Access Compliance Report Public Rights-of-Way (Curb Ramps)

Main Street: **OSO_PKWY** Cross Street: **MEANDERING_TRAIL** Location: **NW**

ADA ID: **RPRK211019150808** Ramp Type: **Type 1 - Perpendicular Diagonal** Initial Pass/Fail: **Fail** Overall Compliance: **No** Severity Score: **30**

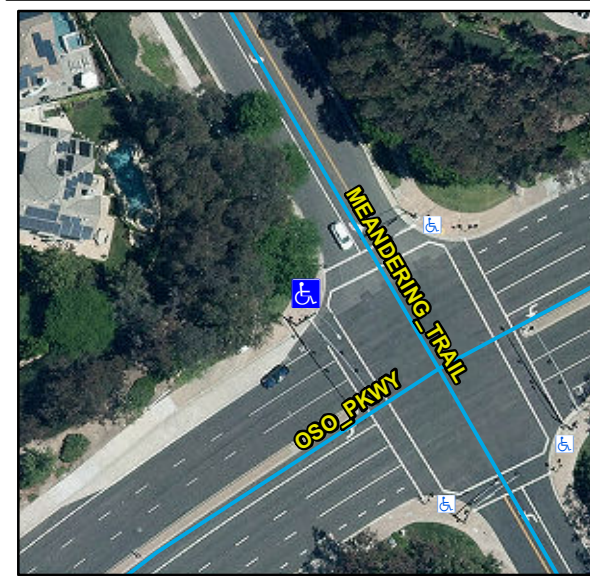
Compliance	Description	Data	Compliance	Description	Data
N/A	Ramp Length (in)	110	N/A	Flare Type LT	
Yes	Ramp Width (in)	48			N/A
Yes	Ramp Run Slope (%)	5.9	N/A	Flare Slope LT (%)	N/A
No	Ramp Cross Slope (%)	7.5	N/A	Flare Traversable LT	N/A
N/A	Landing Present	N/A	N/A	Flare Type RT	
N/A	Landing Length (in)	N/A			N/A
N/A	Landing Width (in)	N/A	N/A	Flare Slope RT (%)	N/A
N/A	Landing Run Slope (%)	N/A	N/A	Flare Traversable RT	N/A
N/A	Landing Cross Slope (%)	N/A	N/A	DWS Provided	N/A
N/A	Landing Movement Obstructed?	N/A	N/A	DWS Contrast	N/A
	Landing Movement Type	N/A	N/A	DWS Length (in)	N/A
N/A	Landing Shared	N/A	N/A	DWS Full Width	N/A
N/A	Clear Space	Yes	N/A	DWS Offset Left (in)	N/A
N/A	Clear Space To Crosswalk (in)	48	N/A	DWS Offset Right (in)	N/A
N/A	Marked Crosswalk 1	Yes	N/A	Marked Crosswalk 2	Yes
	Crossing 1 Direction	S		Crossing 2 Direction	E
	Marked Crosswalk 1 Width (in)	144		Marked Crosswalk 2 Width (in)	144

Possible Solutions:
Remove & Replace Curb Ramp With Two New Directional Ramps or Equivalent.
